Well Name: FULLER 14/11 B2HA FED COM	Well Location: T26S / R29E / SEC 14 / SENE / 32.0429557 / -103.9484386	County or Parish/State: EDDY / NM
Well Number: 1H	Type of Well: OIL WELL	Allottee or Tribe Name:
Lease Number: NMNM011038	Unit or CA Name:	Unit or CA Number:
US Well Number: 3001553435	Operator: MEWBOURNE OIL COMPANY

Type of Action: APD Change

Procedure Description: Mewbourne Oil Company request that the following changes be made to the approved APD for the Fuller 14/11 B2HA Fed Com #1H (APD ID: 10400080306)... Change well name from Fuller 14/11 B2HA Fed Com #1H to Fuller 14/11 Fed Com #527H Change BHL from 100' FNL & 660' FEL (Sec 11) to 100' FNL & 880' FEL (Sec 11) Request permission for BOP break testing and offline cementing

PECOS DISTRICT DRILLING CONDITIONS OF APPROVAL

Figure 2. BOPE diagram

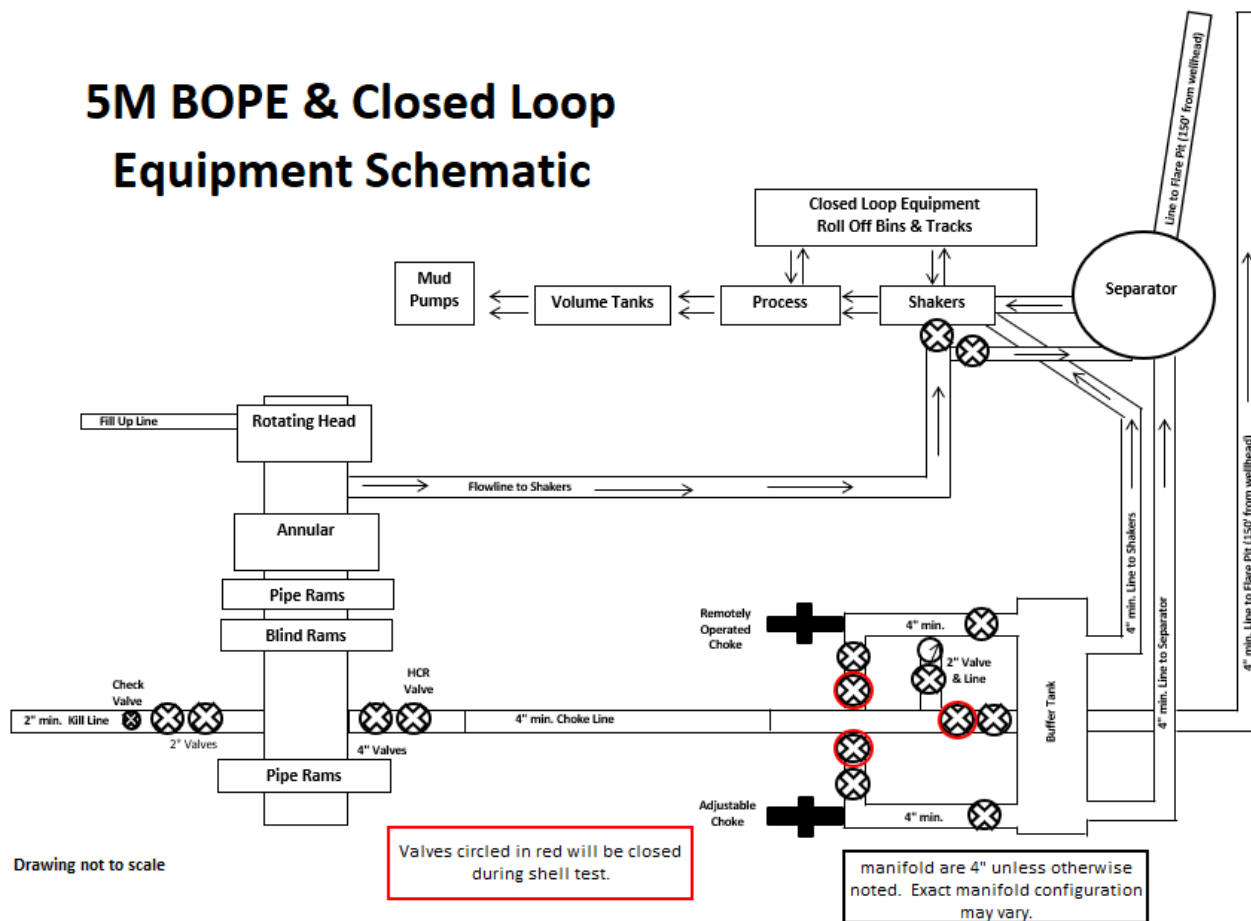
9. A test will then be conducted against the upper pipe rams and choke, testing both breaks (Fig. 1 & 2).
10. The test will be held at 250 psi low and to the high value submitted in the APD, not to exceed 5000 psi.

- BOPE Break Testing is ONLY permitted for 5M BOPE or less. **(Annular preventer must be tested to a minimum of 70% of BOPE working pressure and shall be higher than the MASP)**
- BOPE Break Testing is NOT permitted to drilling the production hole section.
- Variance only pertains to the intermediate hole-sections and no deeper than the Bone Springs formation.
- While in transfer between wells, the BOPE shall be secured by the hydraulic carrier or cradle.
- Any well control event while drilling require notification to the BLM Petroleum Engineer **(575-706-2779)** prior to the commencement of any BOPE Break Testing operations.
- A full BOPE test is required prior to drilling the first deep intermediate hole section. If any subsequent hole interval is deeper than the first, a full BOPE test will be required. (200' TVD tolerance between intermediate shoes is allowable).

- The BLM is to be contacted (**575-361-2822 Eddy County**) 4 hours prior to BOPE tests.
- As a minimum, a full BOPE test shall be performed at **21**-day intervals.
- In the event any repairs or replacement of the BOPE is required, the BOPE shall test as per **43 CFR part 3170 Subpart 3172**.
- If in the event break testing is not utilized, then a full BOPE test would be conducted.

Figure 5. Cactus 5M wellhead with BOP quick connect

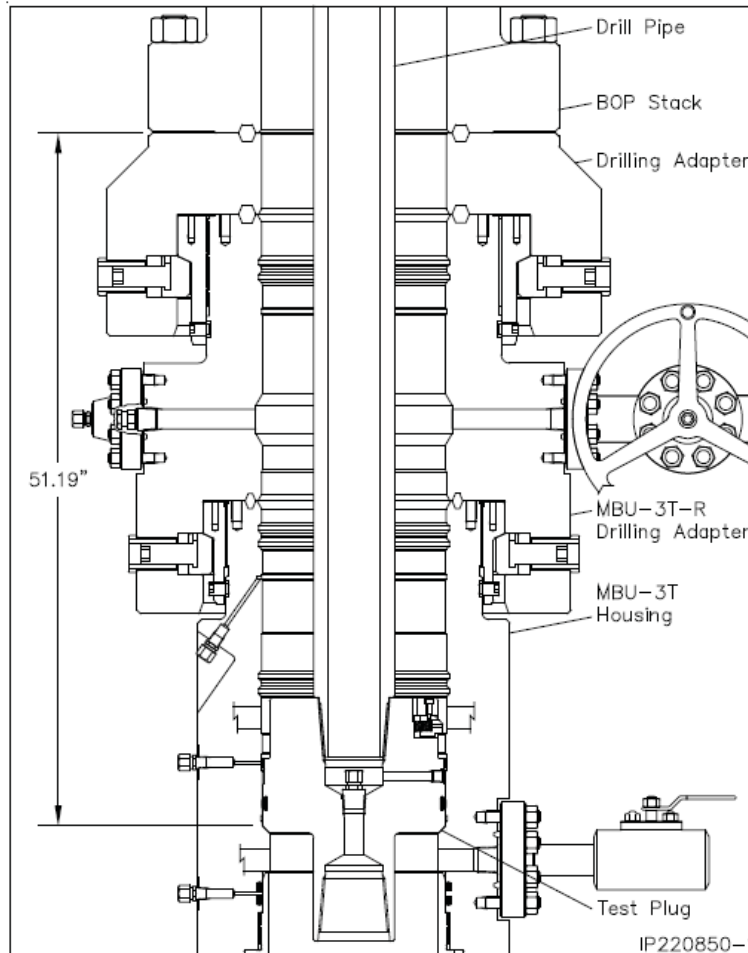
- Connection between the flex line and the HCR valve
 - Connection between the wellhead and the BOP quick connect (Fig. 5 & 6).
3. A capping flange will be installed after cementing per wellhead vendor procedure & casing pressure will be monitored via wellhead valve.
